| T.I. no.: 2025-15 Updated: - | Topic: ABS buffer in grounds container shaft |

| Affected machines: SOUL 10/12 | |

NEW HOLDER FOR COMBINATION SENSOR AND NEW DEVICE BASE

Figure 2: ABS buffer glued into the brewing shaft

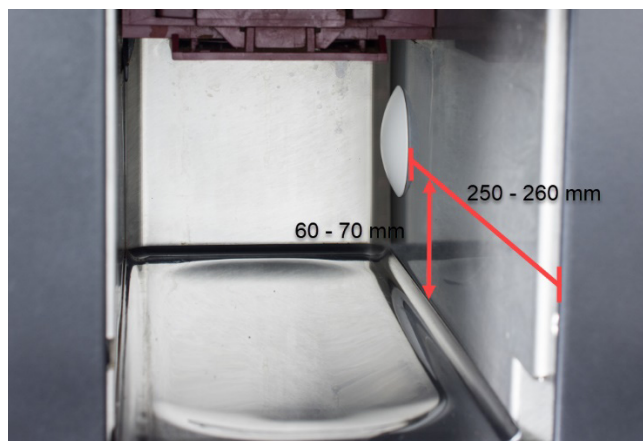
We are receiving an increasing amount of feedback that the grounds container is not detected correctly on some machines if it is positioned slightly too far to the right.

In this case, an ABS buffer (3370074789) must be attached to the rear right-hand side of the grounds container shaft. This pushes the grounds container slightly to the left so that it is correctly detected by the sensor.

- ▶ Clean the gluing point.
- ▶ Remove the protective film from the adhesive on the back and stick the buffer in the position shown.
